Re: Semi-Annual Report Uranerz Energy Corporation Nichols Ranch ISR Project, SUA-1597

Revised pages to the license application are enclosed in accordance with SUA-1597 License Condition 9.4E. An index of change has been included to guide insertion into the license application.

**Nichols Ranch ISR Project
License Number SUA-1597
Docket No.40-9067**

Semi-Annual Report

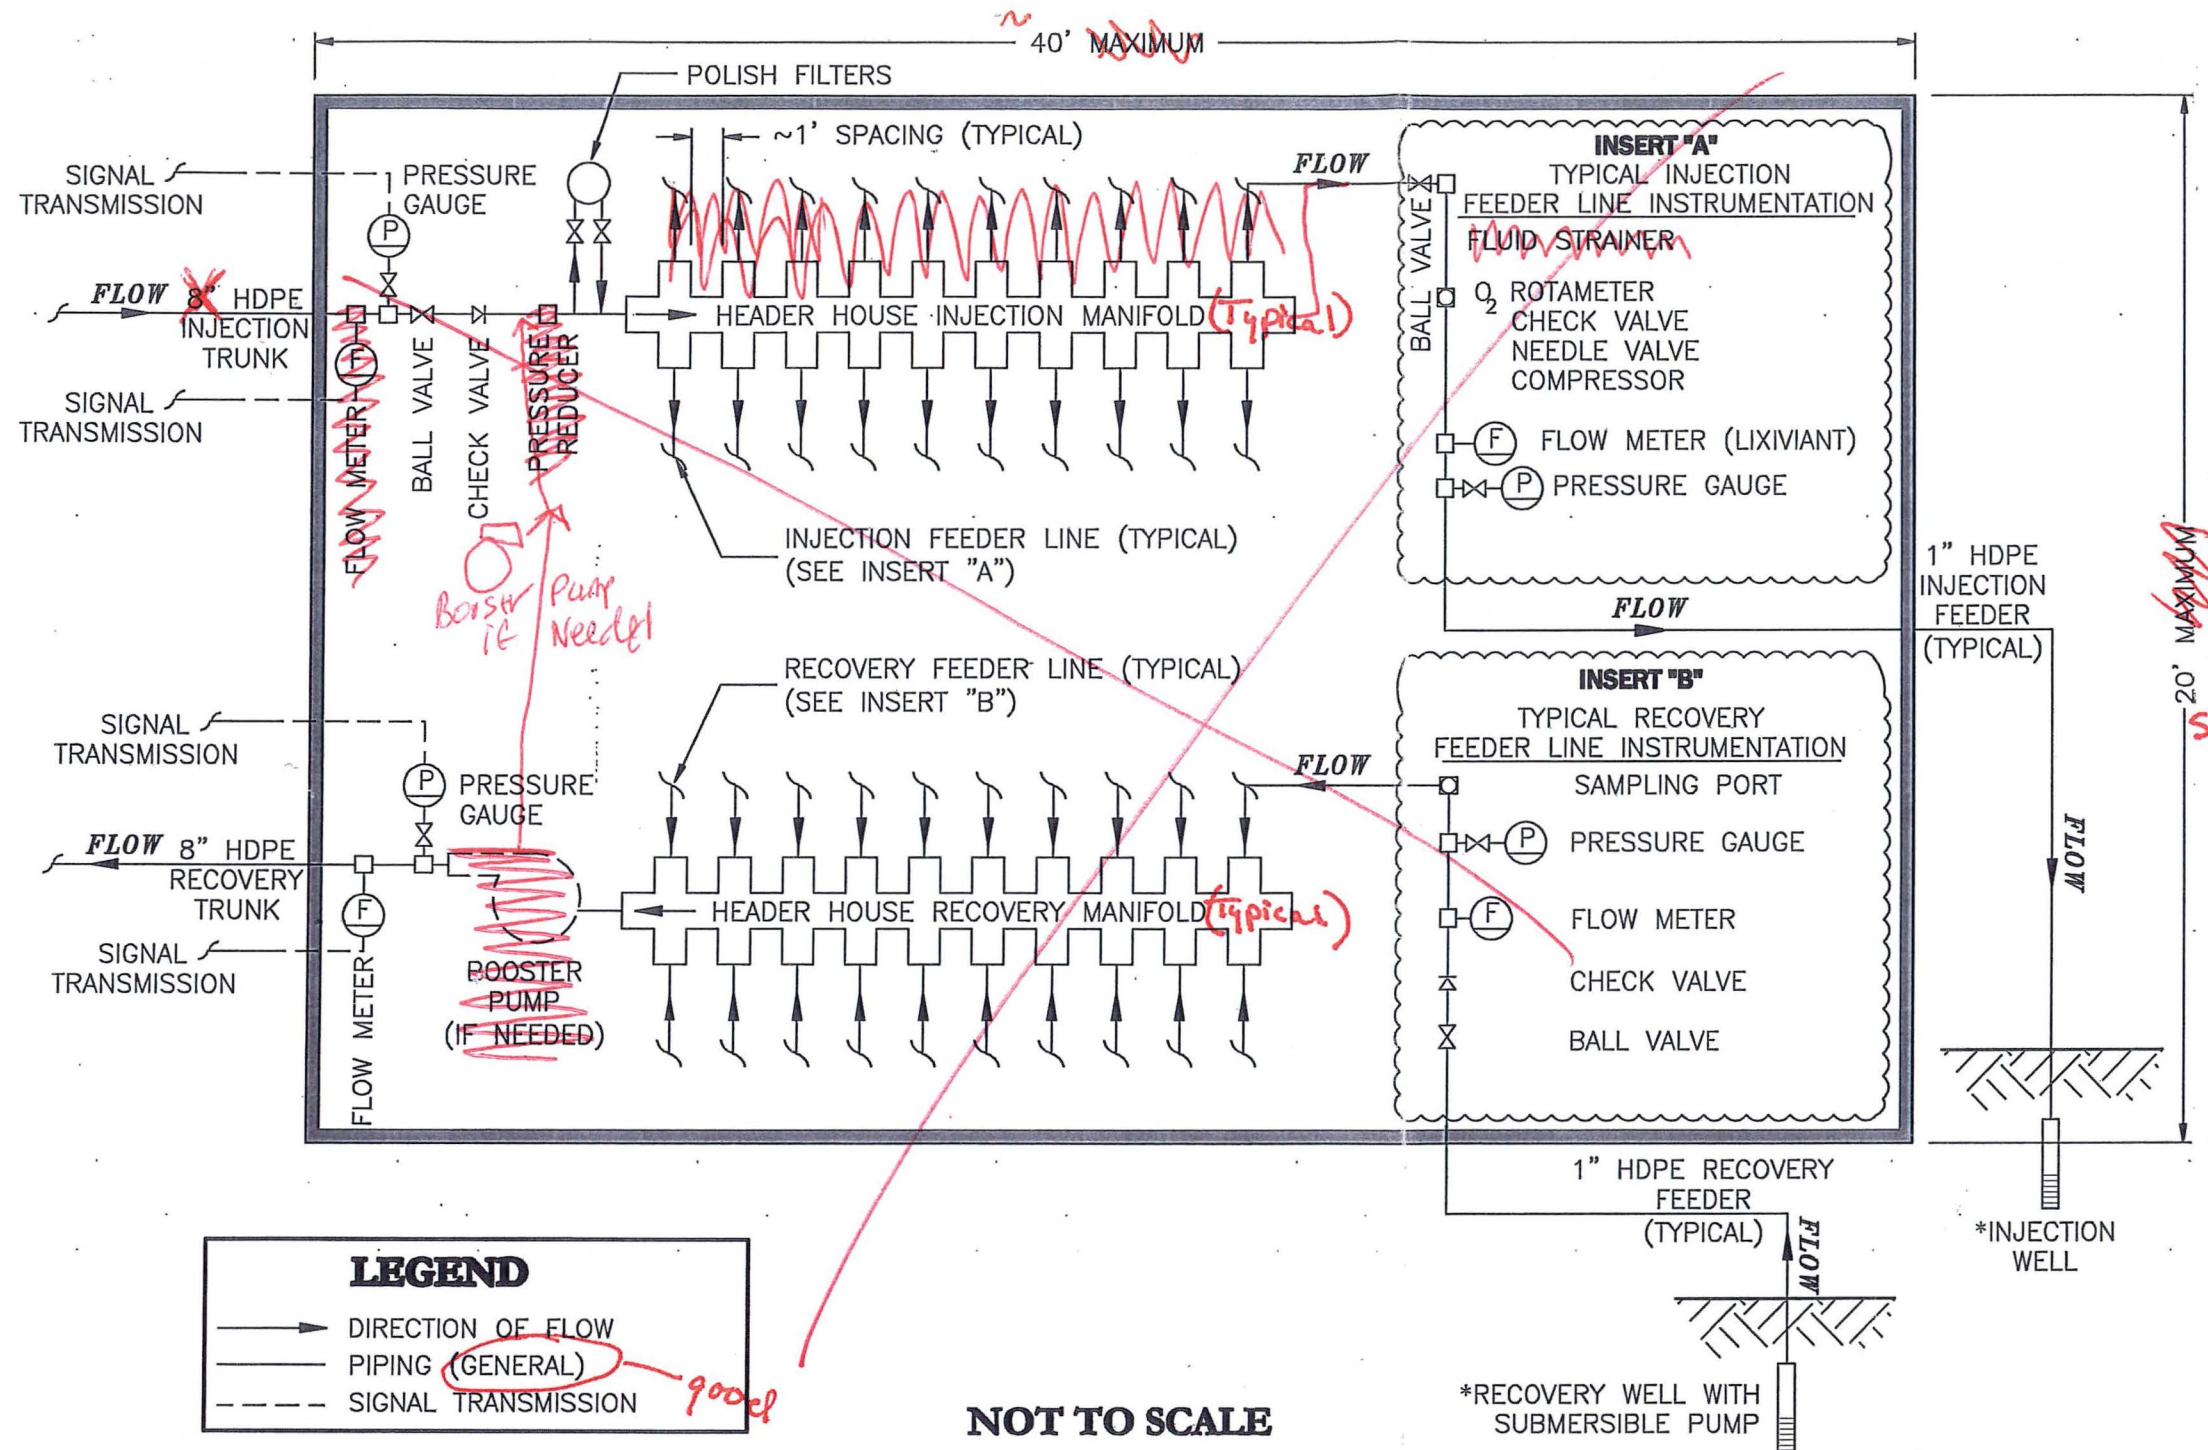
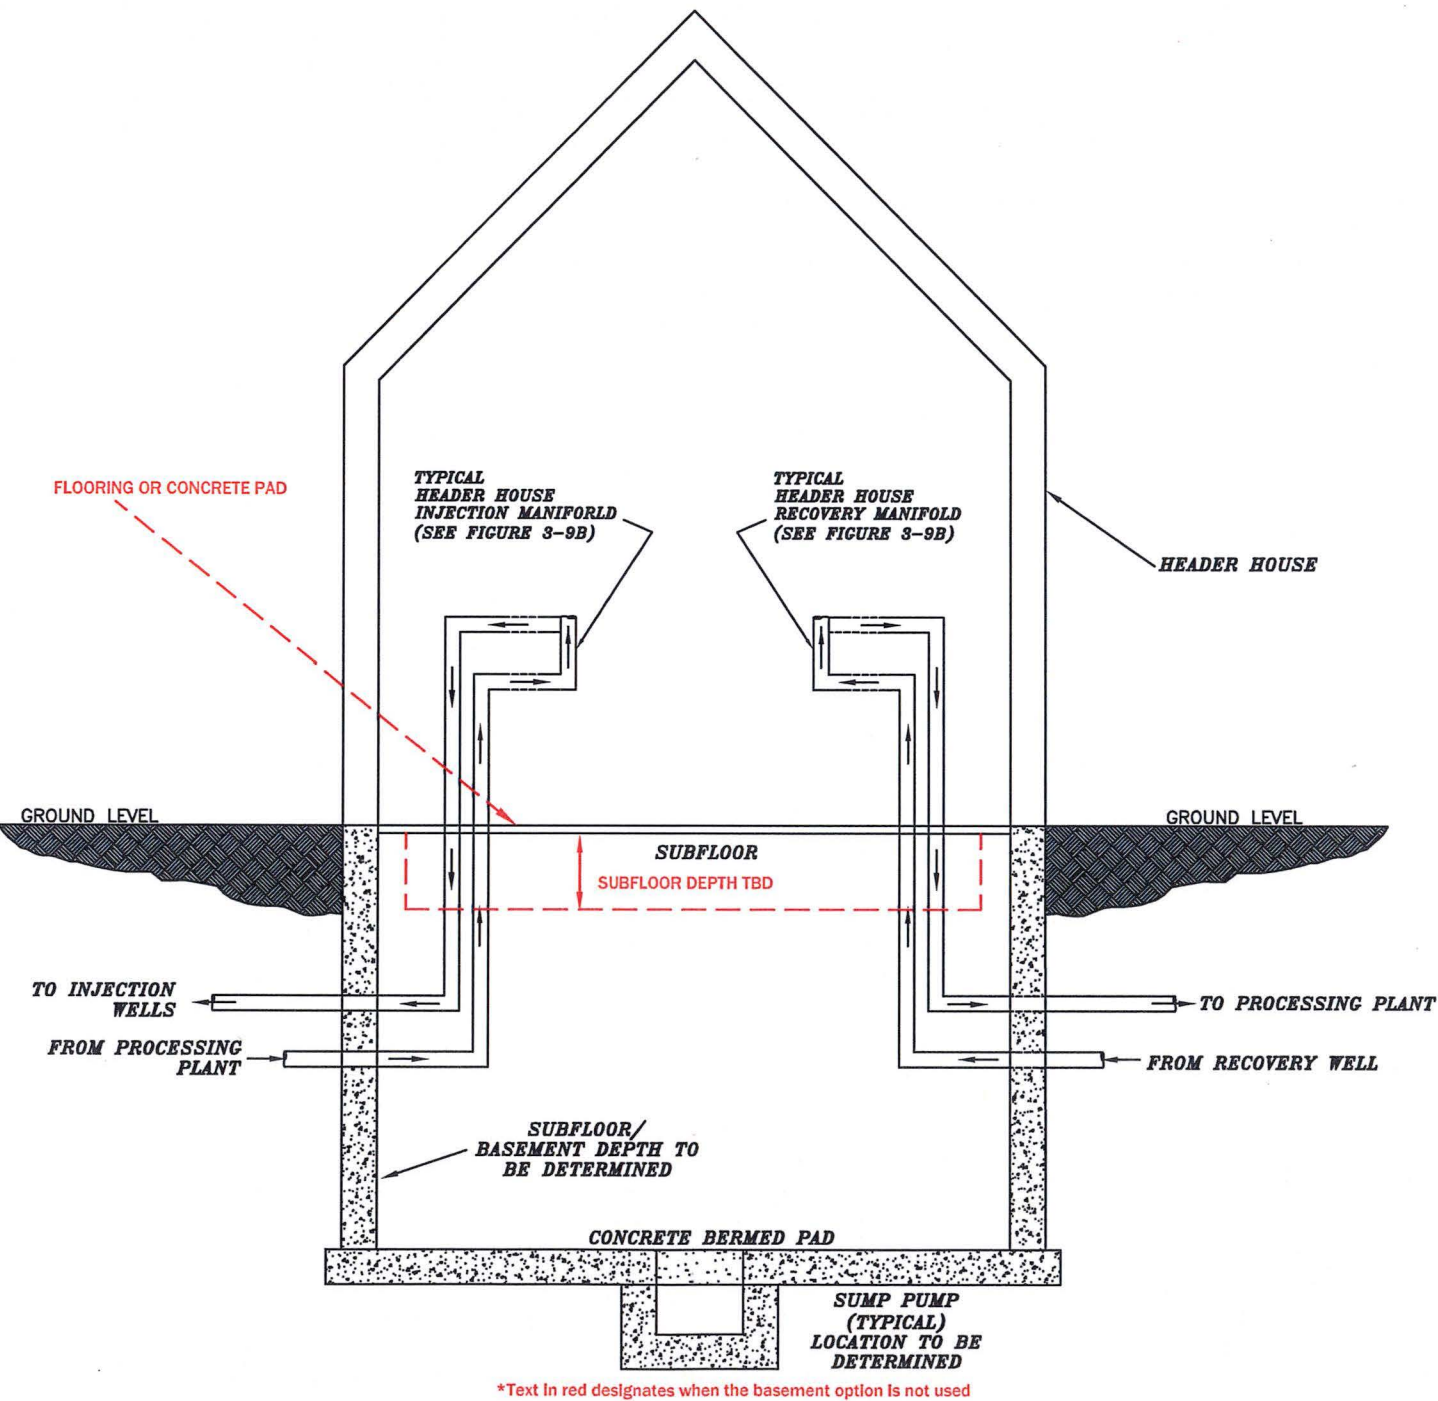
~~inch concrete pad floor.~~ The floor will slope to a sump with an automatic level control pump. The sump will pipe to the recovery system~~line~~ and will include check valves. ~~Design B will have the metal building set on a pad. The inside of the building will be designed so that the main connection valves and hose runs are behind one of two walls that run~~

~~the length of the header house. The walls will be three to four feet from the building edges, and thus allow for maintenance and operators to conduct their inspections and work on the ground level, and not in the sub floor area. In header houses with basements the basement will contain the hose runs and injection and recovery lines. The header house may be designed to contain the electrical equipment in the same room with the piping or the electrical room may be attached to the main header house building and placed on concrete pillars that are buried underground for structural support.~~

The header houses will be metal buildings. The dimensions for the header houses will be approximately 40 feet by 20 feet, but may be more or less. The terrain and logistics in the wellfield will determine which engineered foundation (e.g. pad, pillar, or basement) the header house will be built on. The foundations will be constructed of durable materials that meet engineering requirements or other suitable materials with sealed penetrations (as needed) to provide containment. The foundation will have grating which will allow access to the sub floor containing valves and hose runs. The floor will curb and/or slope to a sump with an automatic level control pump. The sump will pipe to the recovery system and will include check valves. In header houses with basements the basement will contain the hose runs and injection and recovery lines. The header house may be designed to contain the electrical equipment in the same room with the piping or the electrical room may be attached to the main header house building and placed on concrete pillars that are buried underground for structural support.

NICHOLS RANCH ISR PROJECT
FIGURE 3-9A
HEADER HOUSE DETAILS
(TYPICAL)

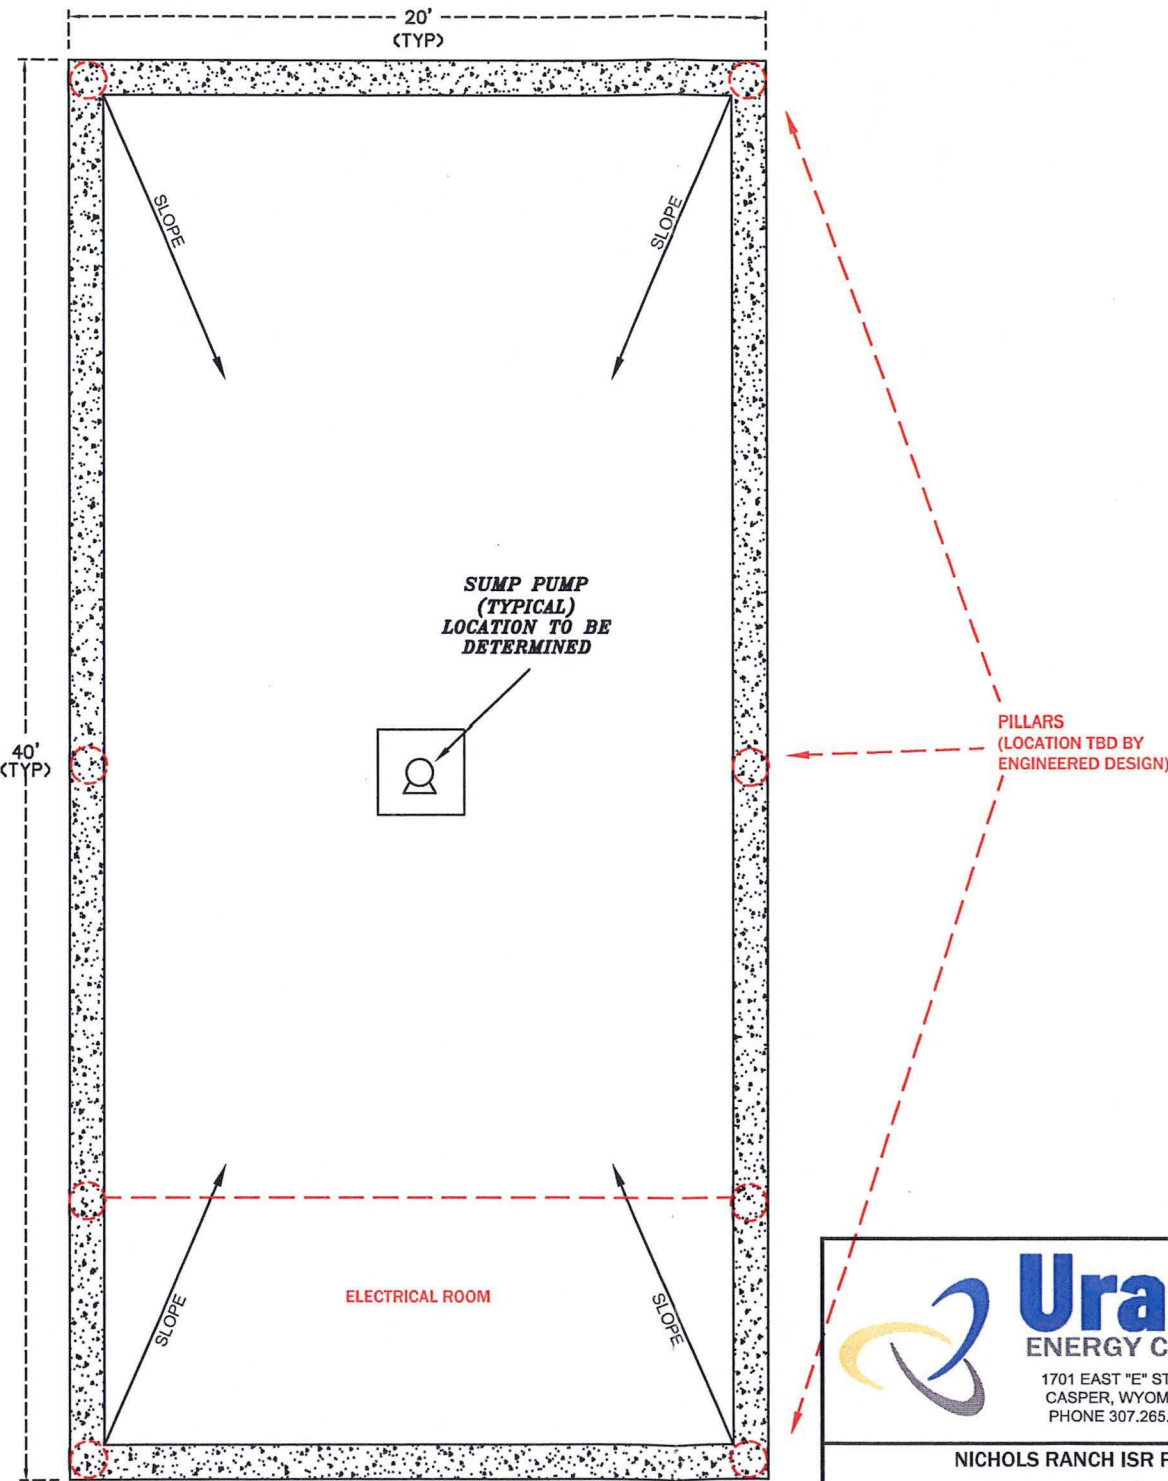
Volume Number	Page, Map or other Permit Entry to be REMOVED	Page, Map or other Permit Entry to be ADDED	Description of Change
Volume I	Pages TR-179 through TR-180a	Pages TR-179 through TR-180a	Changes to description of header house design
Volume I	Table of Contents page TR-ii	Table of Contents page TR-ii	Revised and updated to remove Figure 3-9C
Volume I	Figures 3-9A and 3-9B	Figures 3-9A and 3-9B	Figures were revised to reflect changes to text descriptions on pg TR-170 through TR-180a
Volume I	Figure 3-13	Figure 3-13	Figure updated
Volume I	Figure 5-1	Figure 5-1	Figure updated with new titles and positions per text changes on pages TR-201 through TR-204
Volume I	Pages TR-201 through TR-204	Pages TR-201 through TR-204	Pages revised to include new titles and positions post merger with Energy Fuels
Volume I	Pages TR-309, TR-310	Pages TR-309, TR-310	Pages revised to account for yellowcake slurry shipment

FIGURE 3-9B
HEADER HOUSE PIPING AND INSTRUMENTATION (TYPICAL)

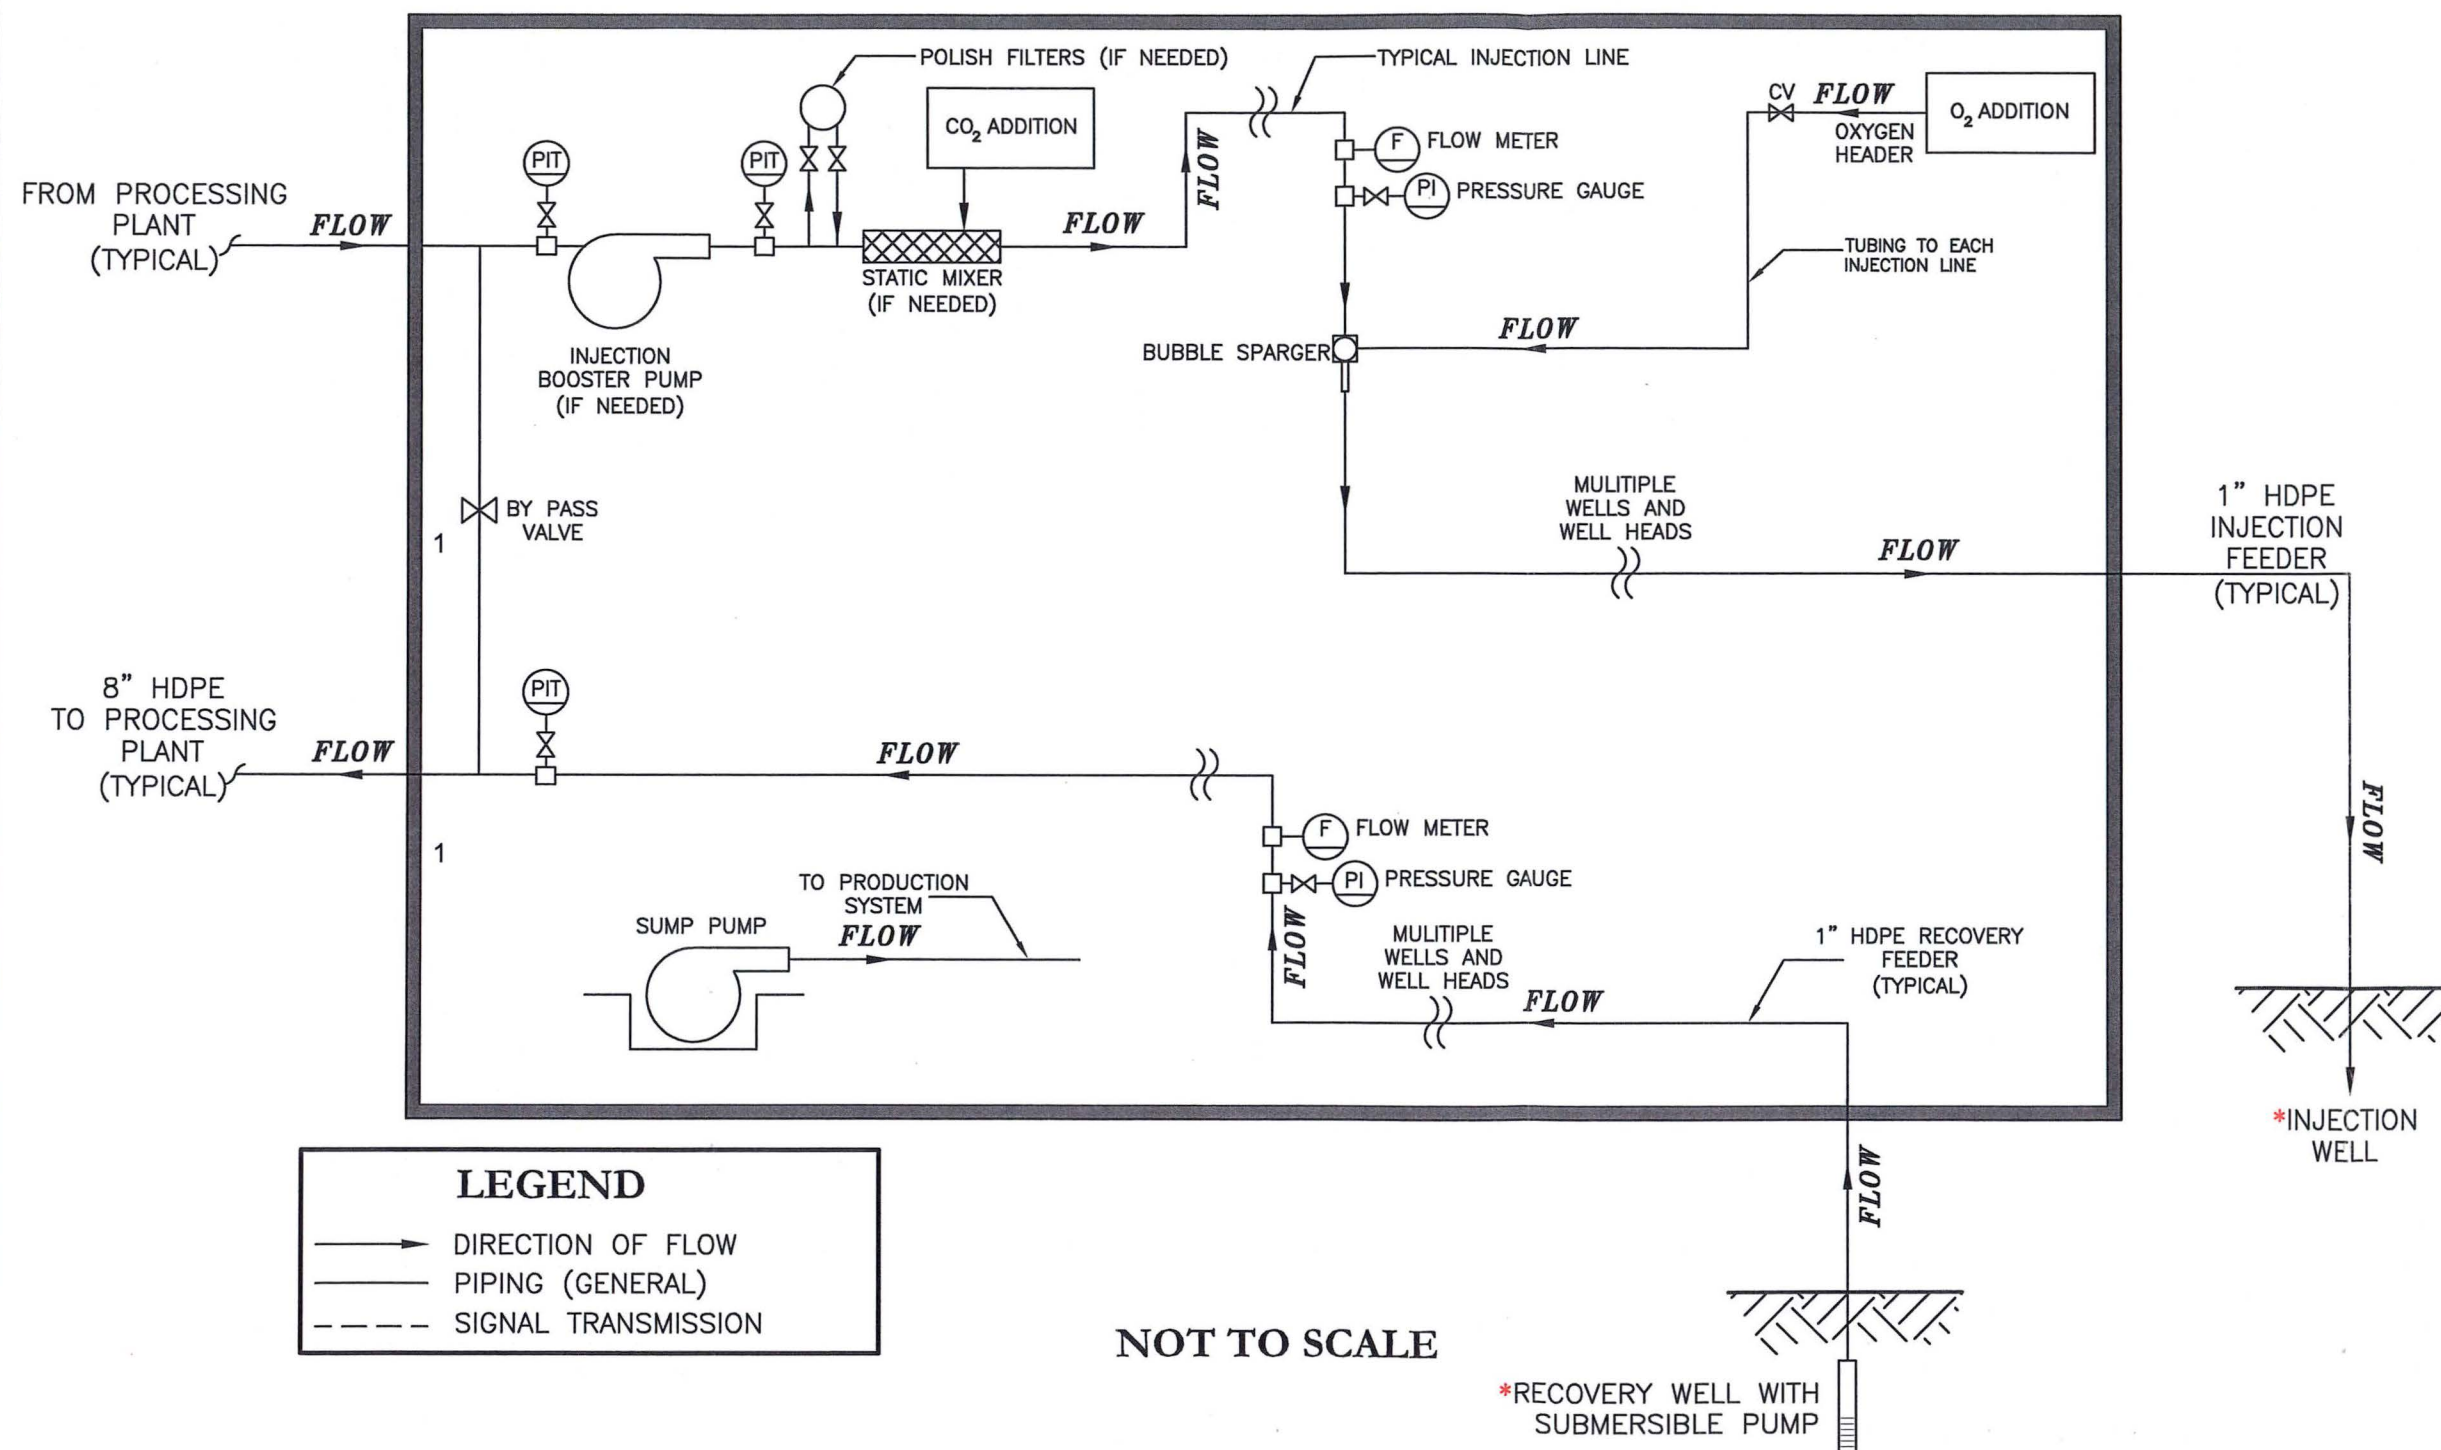
Figure 3-8B Hank Unit Proposed Monitor Well Locations	Map Pocket
Figure 3-9 Typical 5-Spot Well Pattern.....	Map Pocket
Figure 3-9A Header House Details	Map Pocket
Figure 3-9B Header House Ground Level <i>Header House Piping and Instrumentation</i>	Map Pocket
Figure 3-9C Header House Piping and Instrumentation	Map Pocket
Figure 3-10 Nichols Ranch Unit Production Areas	Map Pocket

Delete
Figure
3-9C
altogether
